Intersection ID: 10485	Main Street: ANDERSON_ST	Cross Street: THE_PLAZA	Location:	S
ADA ID: 8E4E4E7E1C9C	Ramp Type: Perpendicular	Initial Pass/Fail: Fail	Overall Compliance: No	Severity Score: 21.25

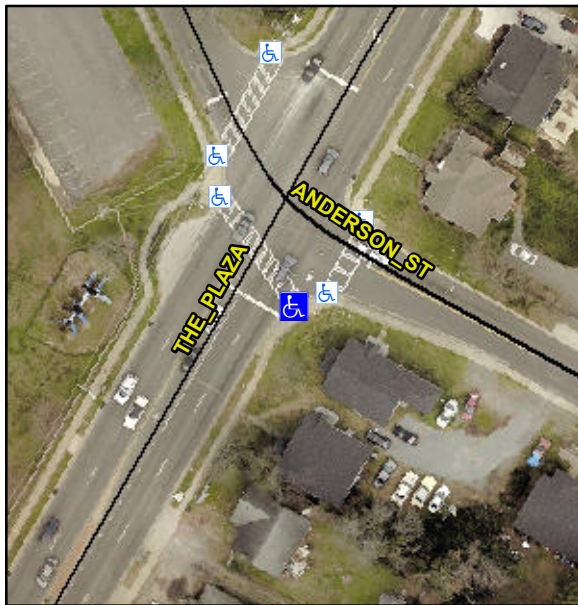
Not Found, R304.5.1, R304.2.2

Remove & Replace Entire Ramp.
